DECEMBER 12, 2012 SAN DIEGO RWQCB WORKSHOP:
Will tentative storm water regulations be applicable to controlling
Sunset Cliffs Natural Park erosion and marine pollution?

DECEMBER 12, 2012 SAN DIEGO R.W.Q.C.B. WORKSHOP
POSSIBLE AREAS FOR USING LID/BMP APPROACHES FOR CONTROLLING AND USING STORM WATER
FROM A POINT LOMA NAZARENE UNIVERSITY (PLNU) AND THE SURFRIDER FOUNDATION GRANT PROPOSAL
AND
SUNSET CLIFF ASSOCIATION (SCA) DATA

FIGURES FOR SCA CCC OCTOBER 3, 2012 PLNU CUP LETTER

Figure 3. Aerial photograph taken November 2, 1986 of the SCNP area and turbid ocean waters.

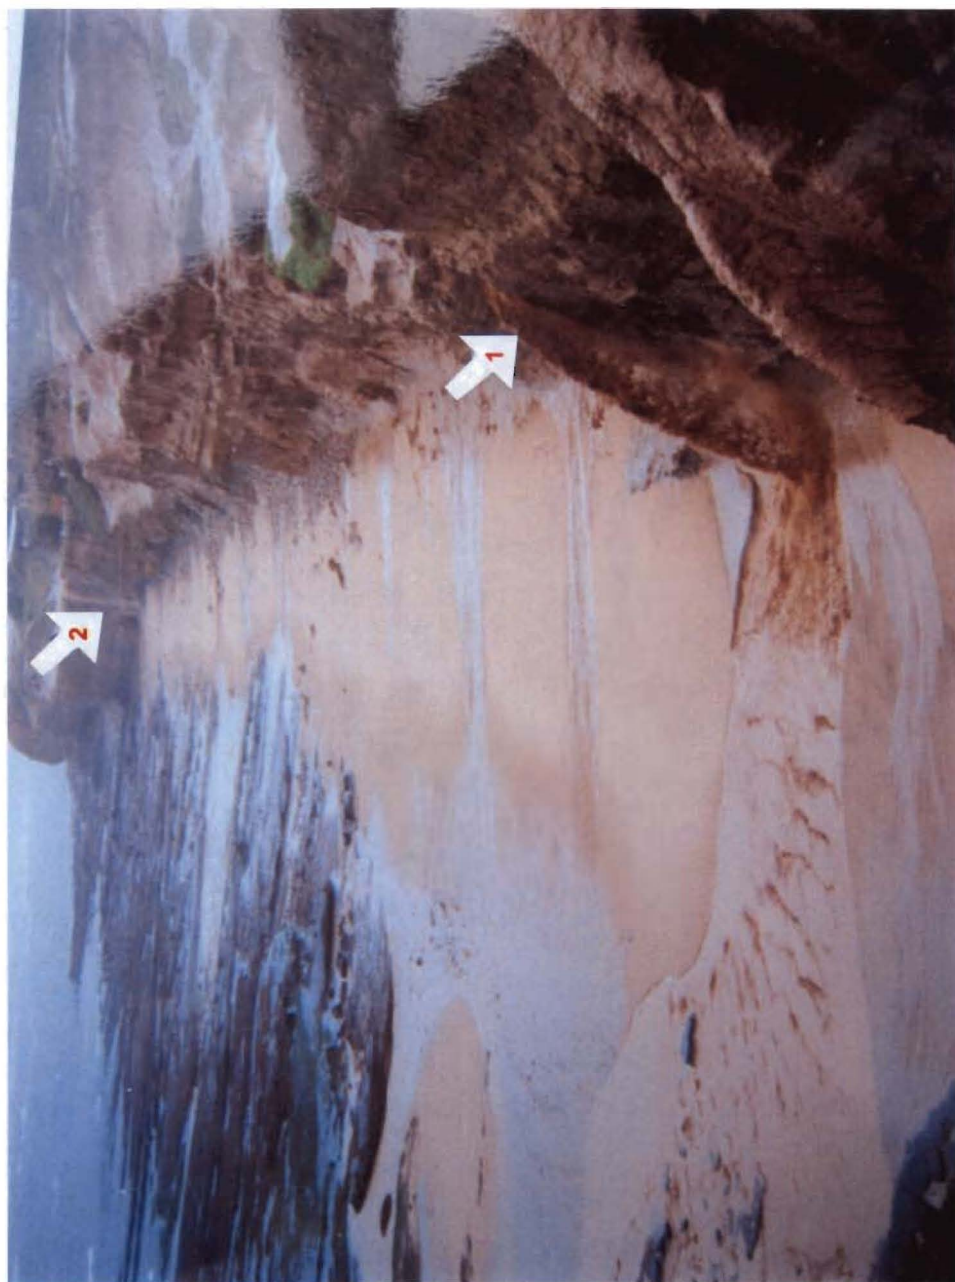
Figure 3. Aerial photograph taken November 2, 1986 of the SCNP area and turbid ocean waters. The turbidity of the ocean waters that is greatest off the southern areas of the SCNP Hillside Park, presumably due to erosion sediments that have been transported to the sea by runoff from SCNP and PLNU. Currents will move the turbidity plume north and southward along the coastline by a number of factors including: tides, wind and prevailing alongshore currents. This photograph is part of an aerial photographic time series for the California coastal zone that is available online, and is compiled by the California Coastal Records Project.

Figure 4. February 2, 2003 photograph of Culvert Canyon turbid storm water runoff discharges.

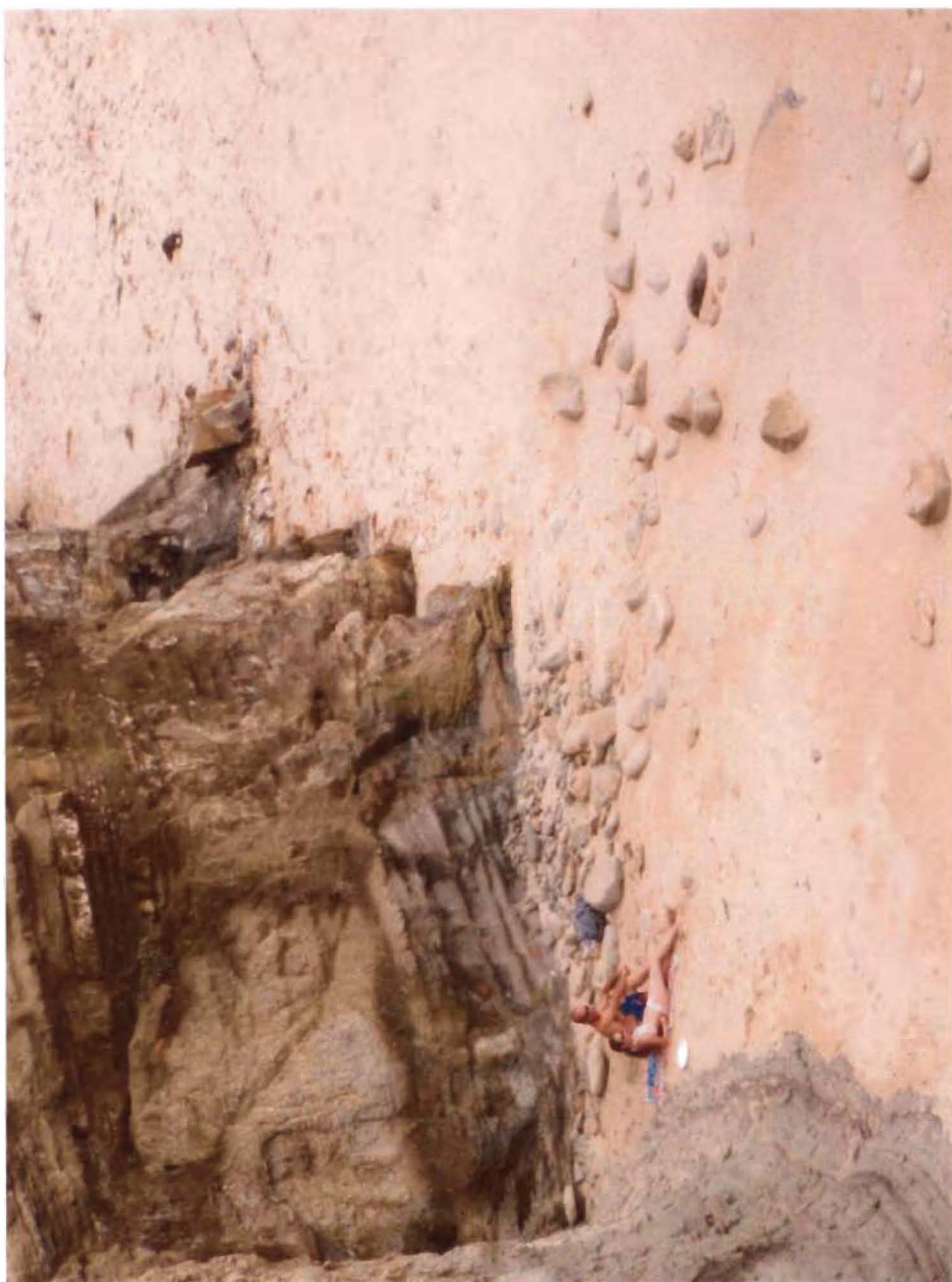
Figure 4. February 2, 2003 photograph of Culvert Canyon turbid storm water runoff discharges. This photograph, taken by Craig Barilotti, shows how turbidity due to sediment discharges from Culvert Canyon after being introduced into the coastal waters, moves offshore and alongshore depending on prevailing currents, in this case northward towards Ocean Beach.

FIGURE
ES-4

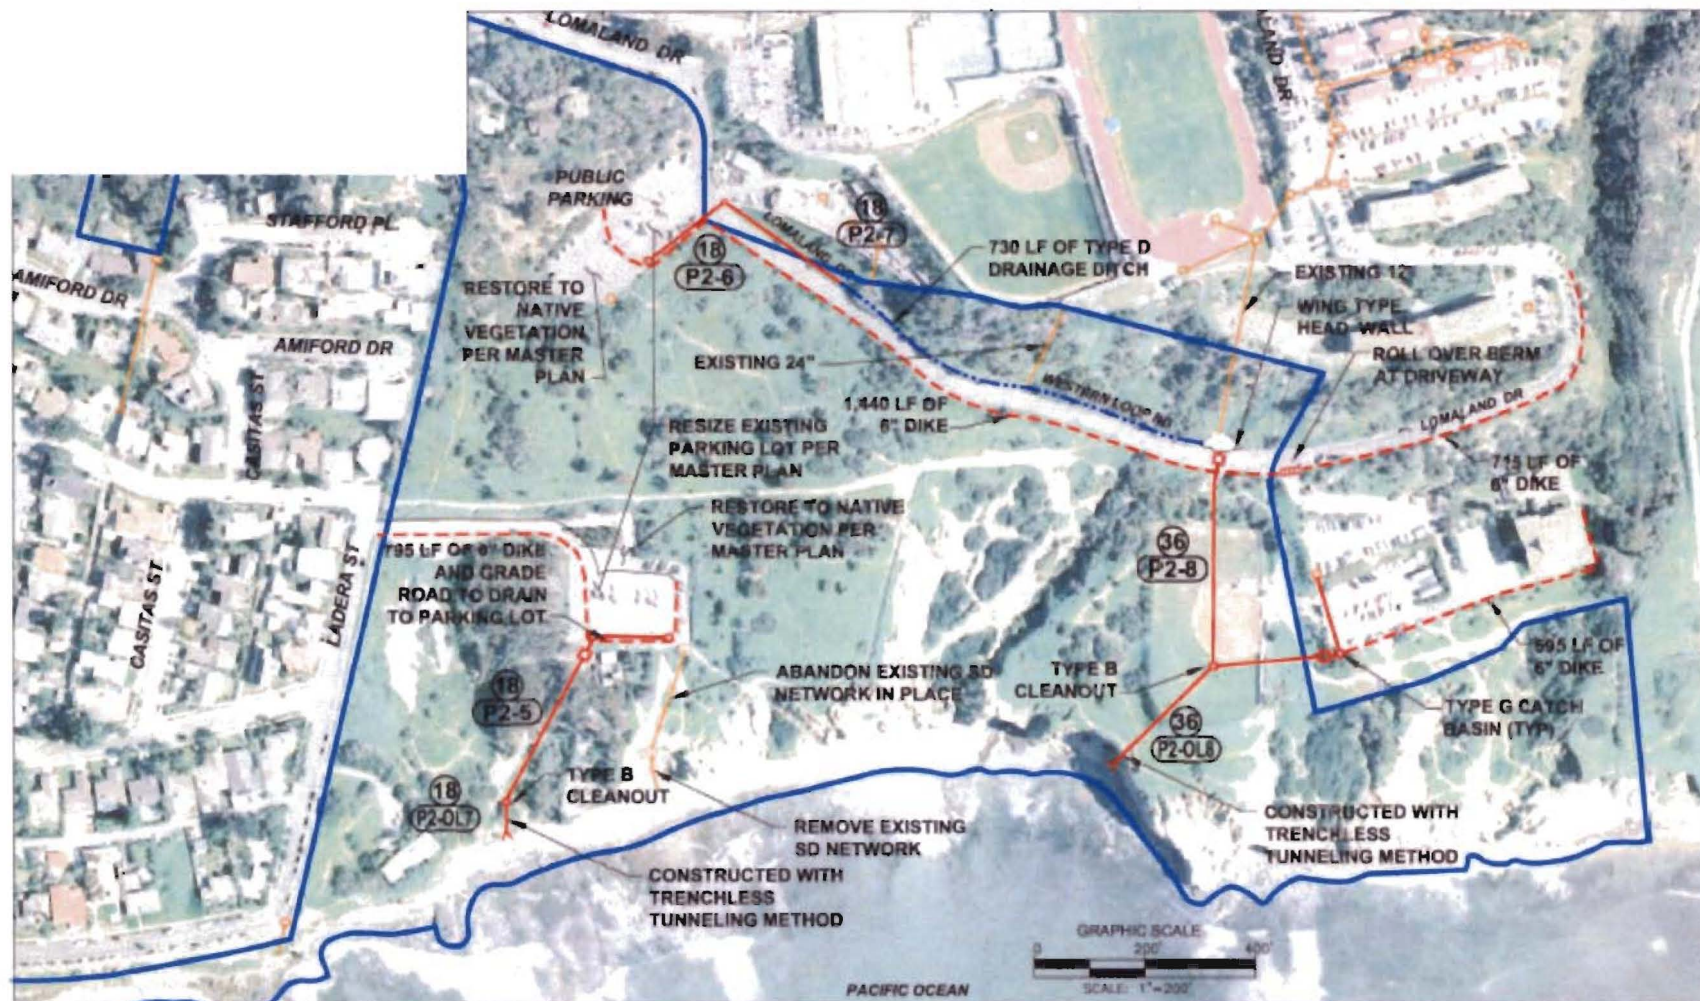
The big pipe solution itself would have significant impact on the park but, more importantly, it would not protect the ocean from sediment laden runoff discharge into marine waters and habitats.

That is not to say that the PNLU plan 2012 is not better than the PNLU plan 1992, but it nonetheless does not correct future erosion problems, as required by its CUP item 38e. These past current and future problems could be altogether avoided by the application of current standards of care reflected in BMPs, LID, Storm Water Regulations and good engineering practices.

I hope that your group will take a leadership role to get planning and implementation of storm water control measures by PLNU that will eliminate PLNU storm water runoff into the SCNP. Simply put, the 2012 PNLU Drainage Plan should be rejected. PLNU needs a storm water management plan, not a drainage plan. Such a plan would cure future erosion problems and allow the development of a natural park as reflected in the SCNP Master Plan.

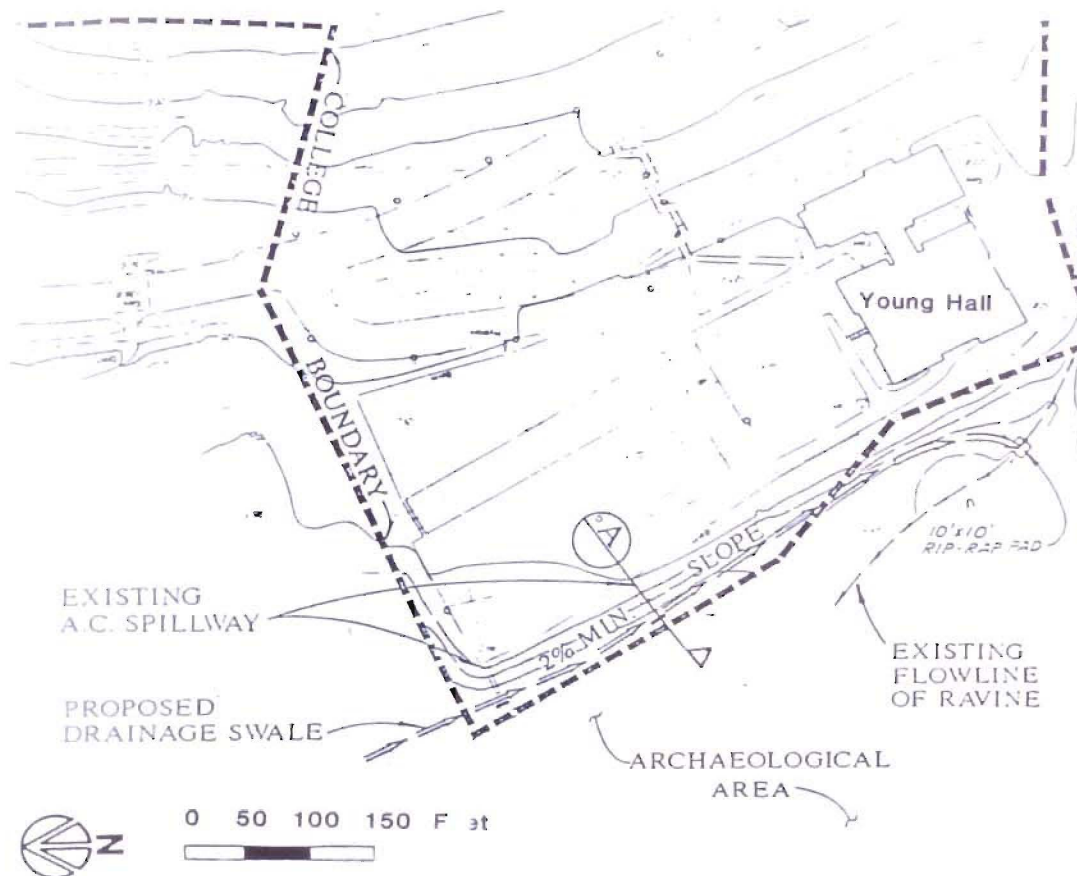
Figure 5. Diagram from the 1992 PLNU Young Hall drainage plan EIR. This design was prompted by concerns for protecting the California registered Native American archeological sites that are just to the west of Young Hall on SCNP property. The discharge structure shown in this diagram and page 3 of the 1992 Drainage System Plans was to have been on SCNP property where it discharged into South Canyon, in part to protect the archeological sites from the Young Hall runoff. The 2012 PLNU Drainage Plan proposes to discharge into velocity dissipaters located on PLNU property, and during periods of heavy rainfall when the drainage system retention capacity is reached, runoff is expected to flow across the PLNU/SCNP property line with a velocity of 2.5 feet per second and into the parkland where the archeological sites are located. The potential for erosion due to Young Hall runoff was demonstrated during the 2004 – 2005 wet season (see Figure 2), when runoff from the Young Hall caused major erosion in the archeological area shown on the EIR diagram.
